Appendix 3: Compilation of all quantitative and qualitative feedback received from testers

Compiled on 2026-01-06 from individual tester submissions. Participant identifiers are preserved as provided in the packs.

Appendix: Visual suggestion exports (Figma)

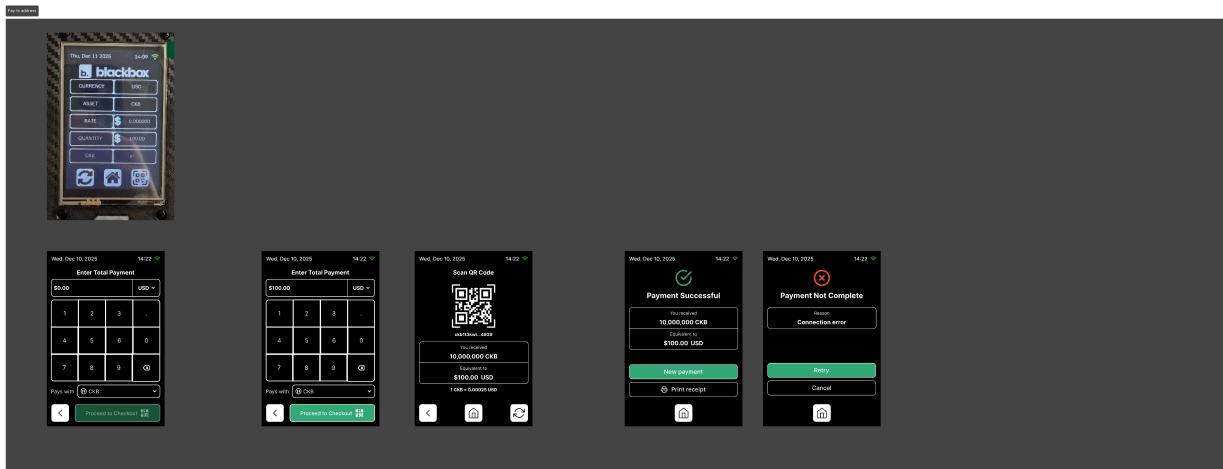
Scan & Store address

WIFI connection

Sales checkout

Pay to address
